ND-13-0494
10 CFR 50.90
10 CFR 52.63

Southern Nuclear Operating Company
Vogtle Electric Generating Plant Units 3 and 4
Request for License Amendment and Exemption:
Turbine Building Battery Room and Electrical Changes (LAR-13-007)

**Turbine Building Battery Room and Electrical Changes
(LAR-13-007)**

Figure 2.6.2-1 (Sheet 1 of 2)
Non-Class 1E dc and Uninterruptible
Power Supply System

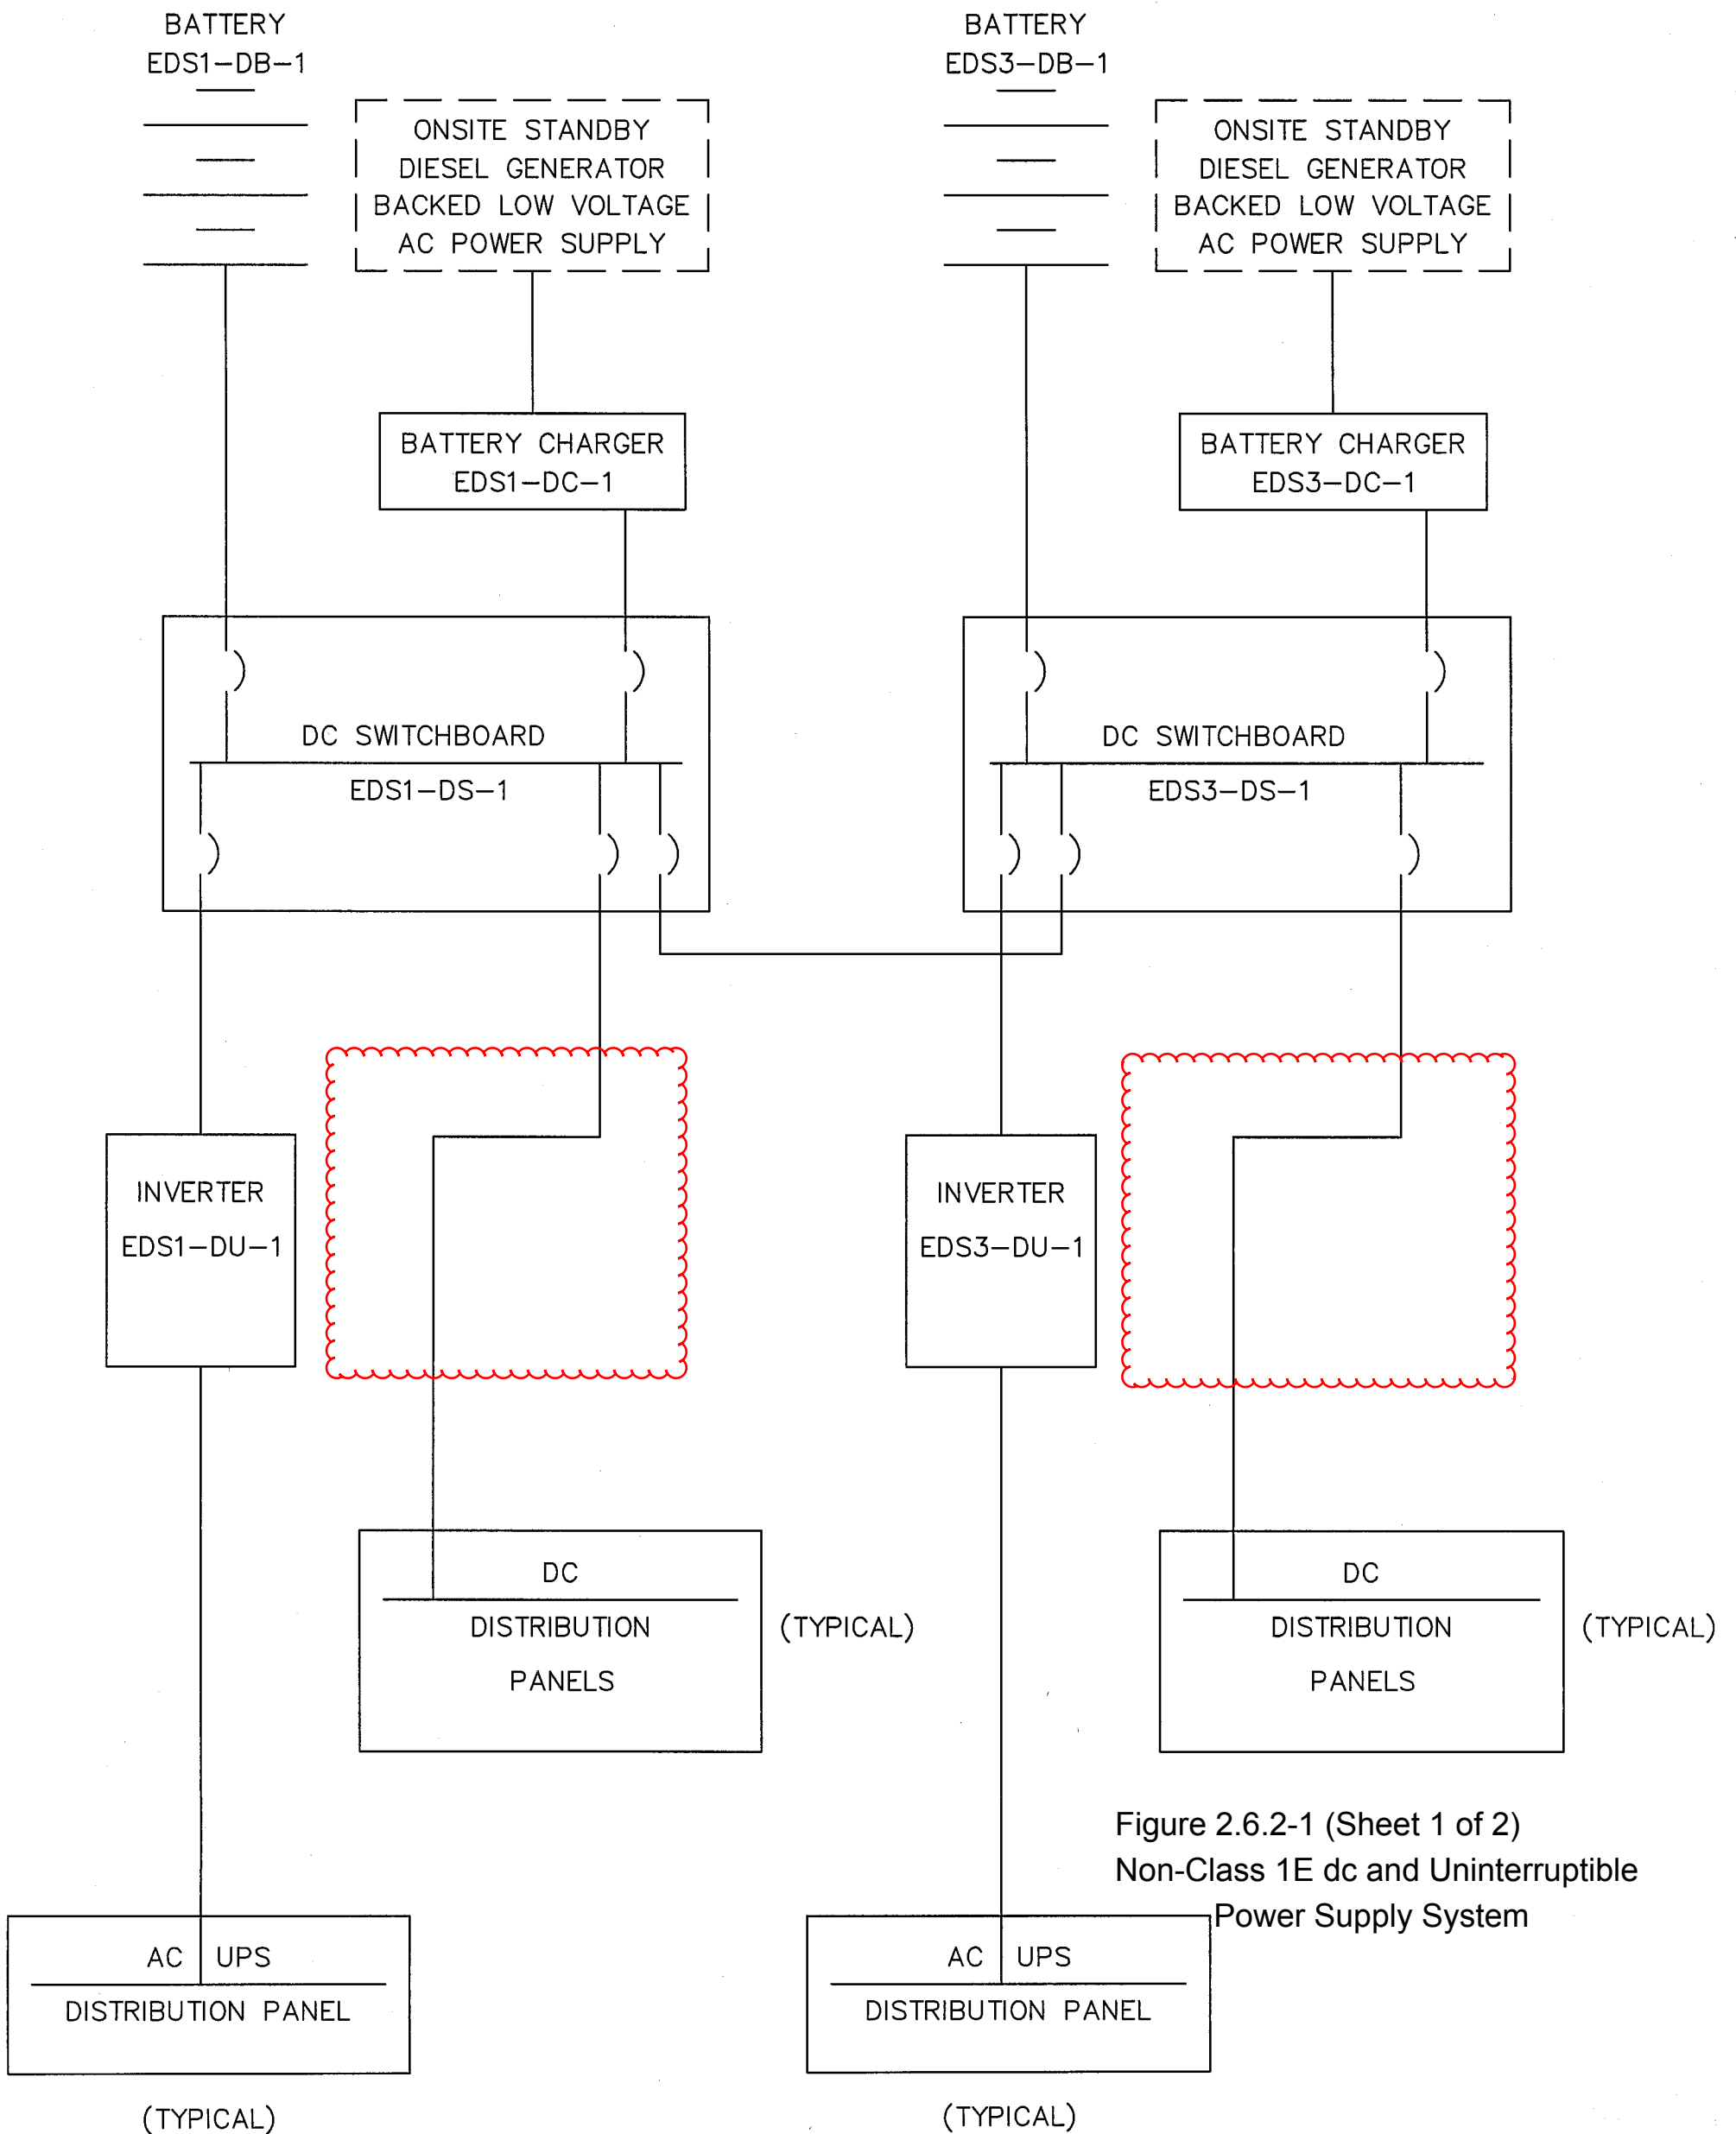
- Table 2.6.2-1
 - Increase each Non-Class 1E dc and Uninterruptible Power Supply System (EDS) battery charger output current testing load from 550 amps to 900 amps, increase each EDS battery testing load from 500 amps to 850 amps, and increase each inverter testing resistive load from 35 kW to 55 kW; delete four load group 125 Vdc (EDS (1, 2, 3, and 4)-DS-11) switchboards,
 - Delete four (EDS (1, 2, 3, and 4)-DS-11) switchboards.
- Table 2.6.2-1
 - Delete four load group 125 Vdc (EDS (1, 2, 3, and 4)-DS-11) switchboards.
- Table 2.6.3-1 & 2.6.3-4
 - Remove the Class 1E dc and Uninterruptible Power Supply System (IDS) Spare Battery 125/250 Vdc Disconnect Switch IDSS-SW-1 and Spare Termination Box IDSS-DF-6

Figure 8.3.2-1 (Sheet 2 of 2) Class 1E DC System One Line Diagram

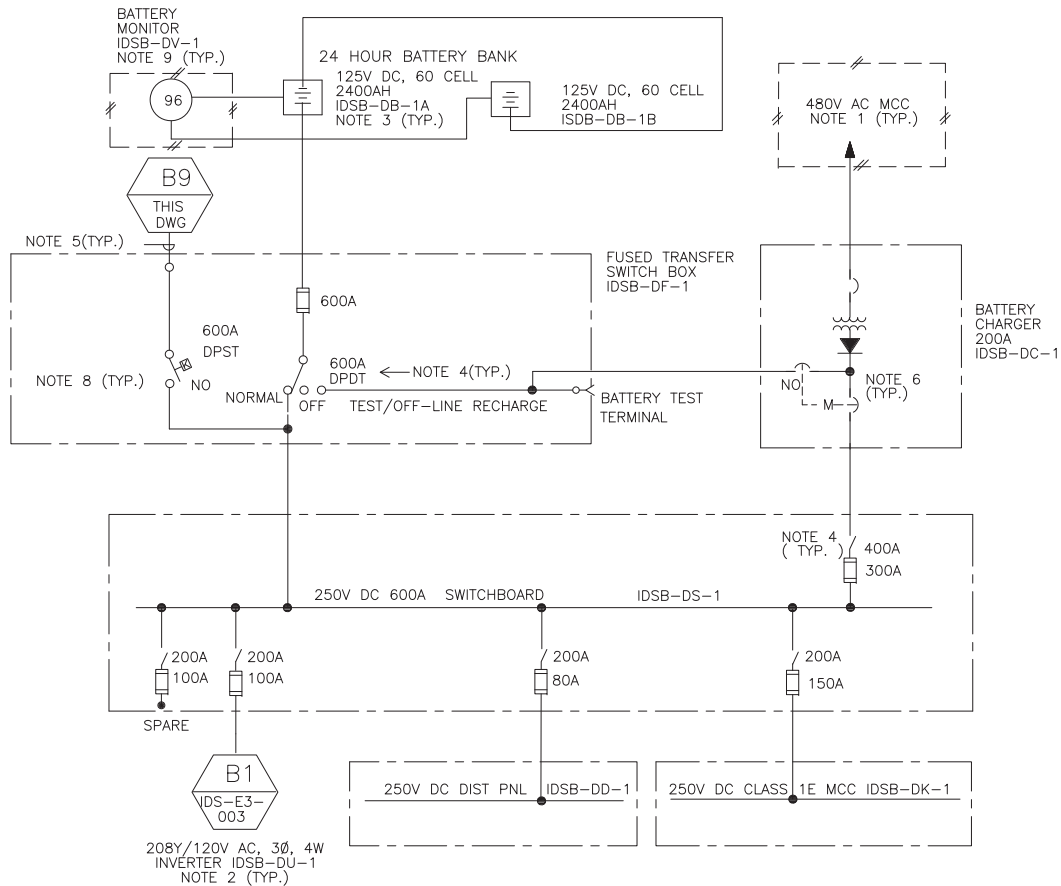
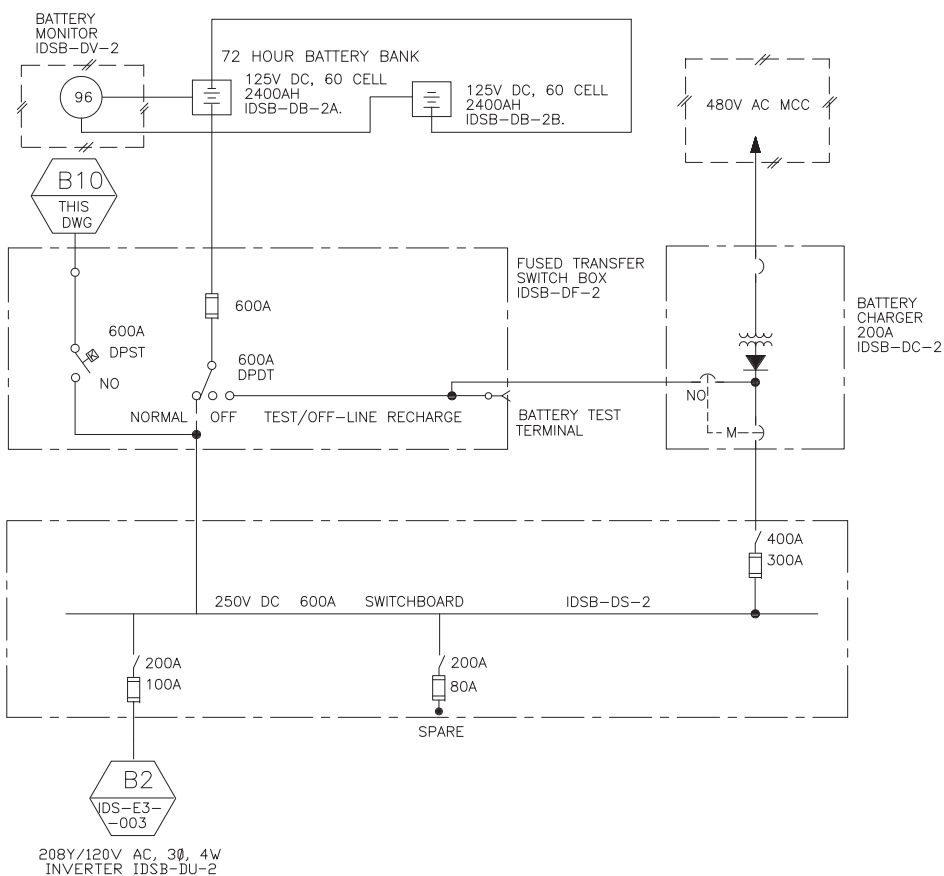
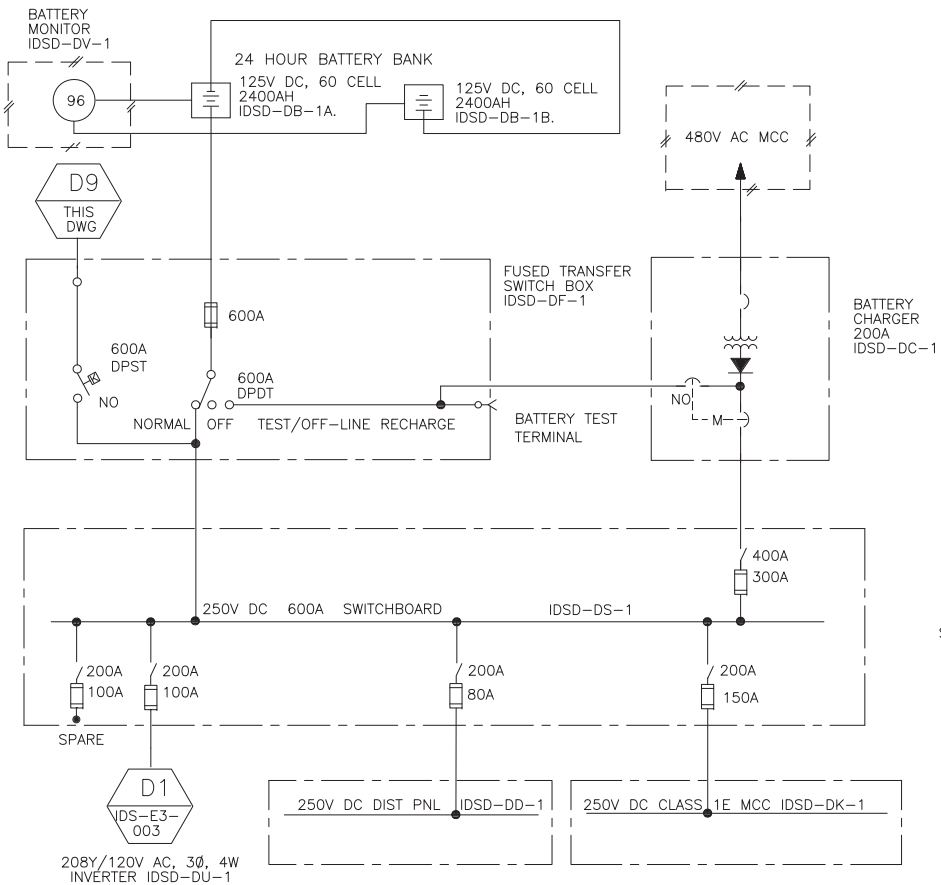
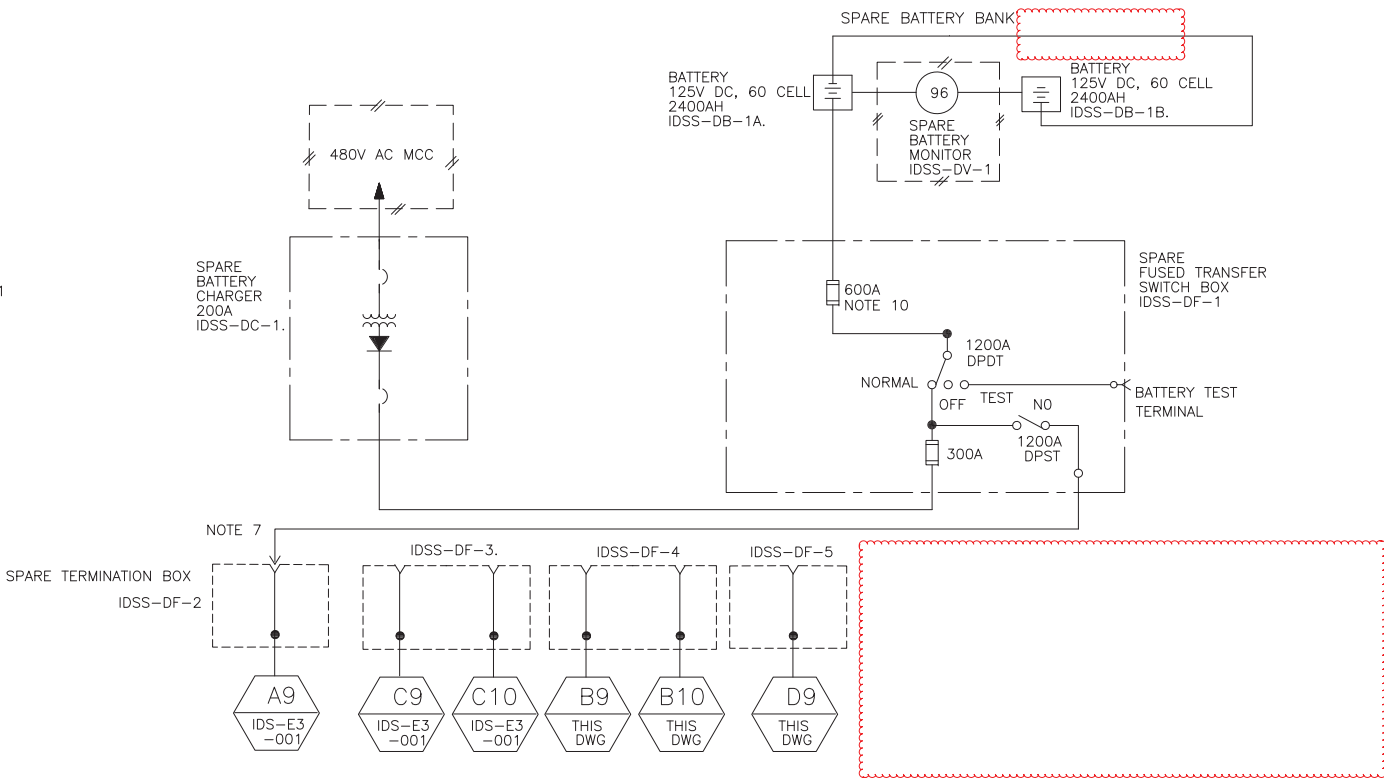
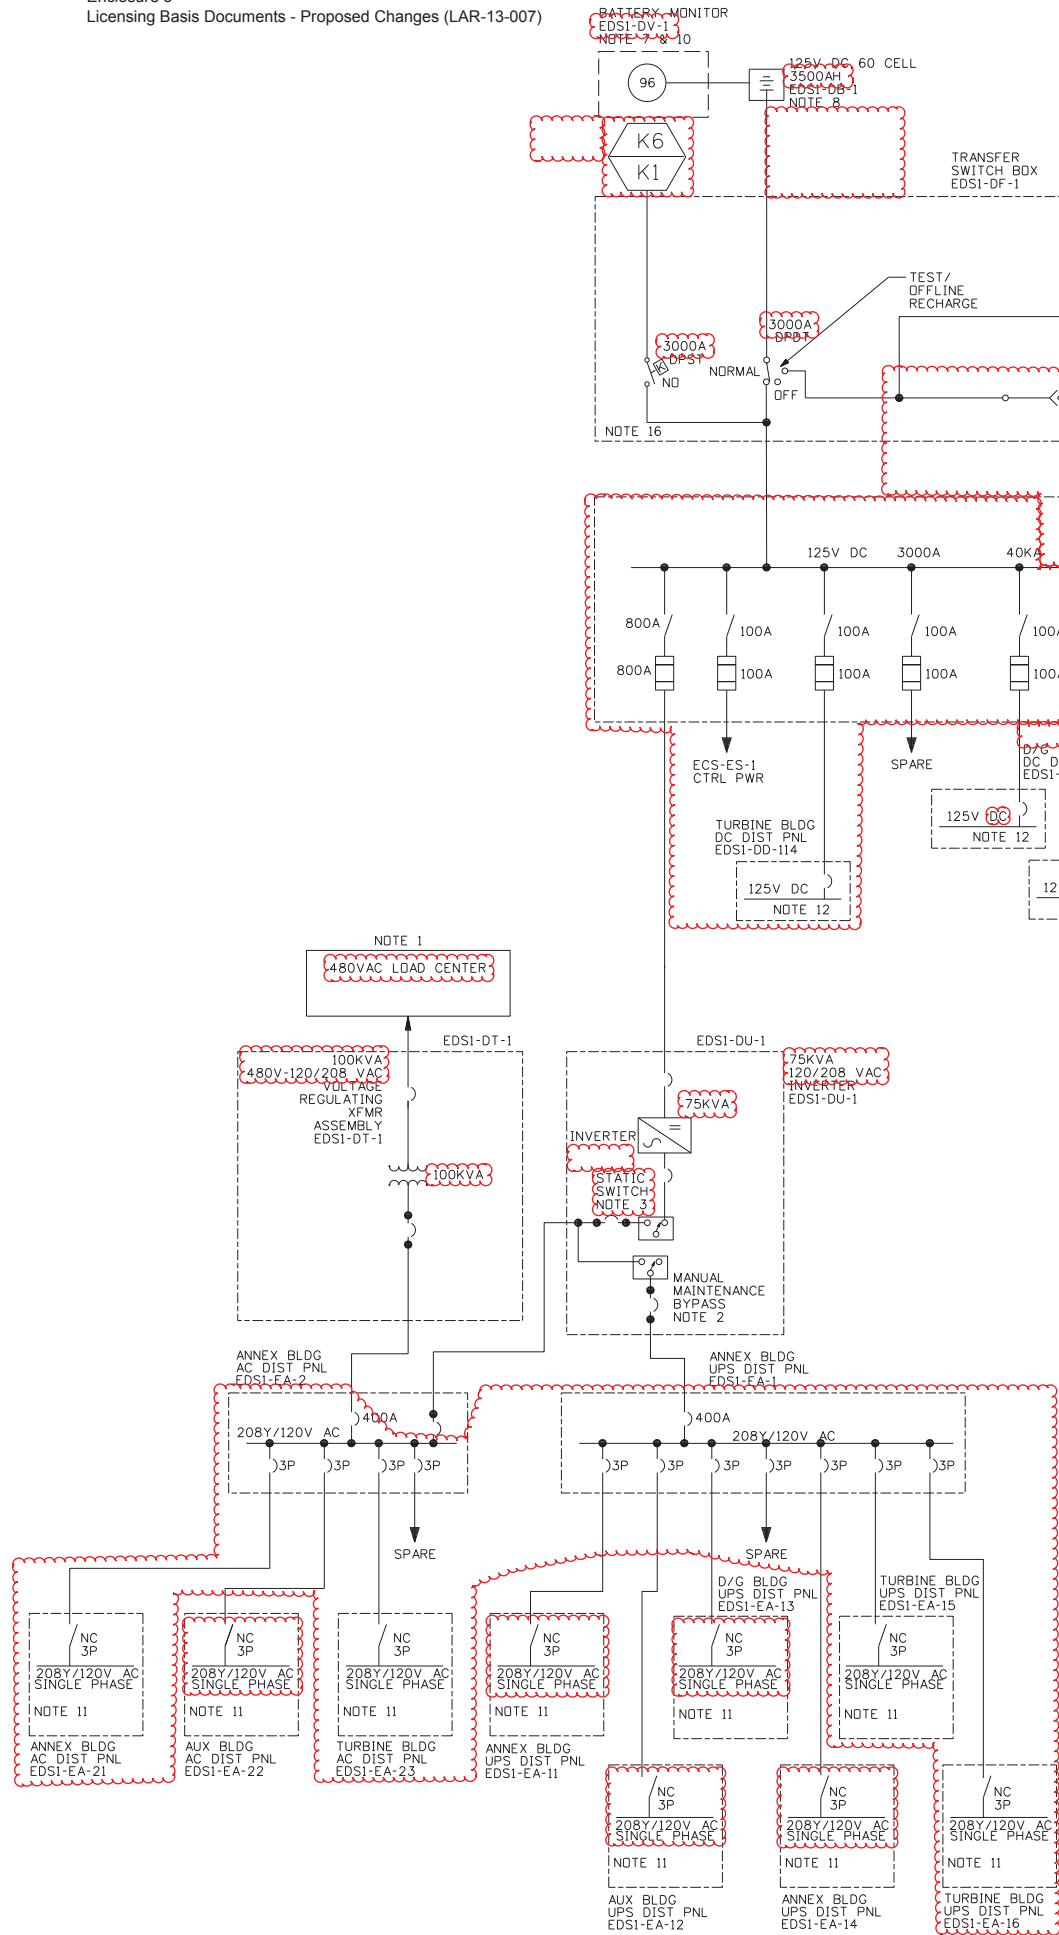
This proposed change includes removal of the tie between the Class 1E IDS spare battery (IDSS) and the non-Class 1E batteries (EDS1 through 5), and the addition of a larger capacity spare EDS battery, chargers and fused transfer switch box to perform the same function, which satisfies the Utility Requirements Document (URD) Volume III Chapter 11 Subsection 7.3.1.4 requirement for a "... standby, backup dc source". The EDS battery load demand increased such that the smaller IDS Spare (IDSS) battery capacity could no longer meet the back-up load requirement. The proposed larger capacity EDS spare (EDSS) battery, chargers and fused transfer switch box would be located in the TB first bay in the relocated EDS Battery Room and Charger Room. This proposed change also would result in the removal of some IDS equipment (i.e., Spare Battery 125/250 Vdc Disconnect Switch IDSS-SW-1 and IDS Spare Termination Box (IDSS-DF-6)) as a result of disconnecting the IDSS battery tie to EDS.

~~The non-Class 1E dc system uses the Class 1E spare battery bank (Figure 8.3.2-1) as a temporary replacement for any primary non-Class 1E battery bank. In this design configuration, the spare Class 1E battery bank would be connected to the non-Class 1E dc bus, but could not simultaneously supply Class 1E safety loads nor perform safety-related functions. For EDS1 through EDS4, this is accomplished by opening the disconnect switch between the two 125 Vdc battery cell strings, which together, comprise the 250 Vdc spare battery. Additionally, the design includes two current interrupting devices placed in series with the main feed from the spare battery that are fault current activated. This will preserve the spare Class 1E battery integrity should the non-Class 1E bus experience an electrical fault. This arrangement will not degrade the electrical independence of the Class 1E safety circuits.~~
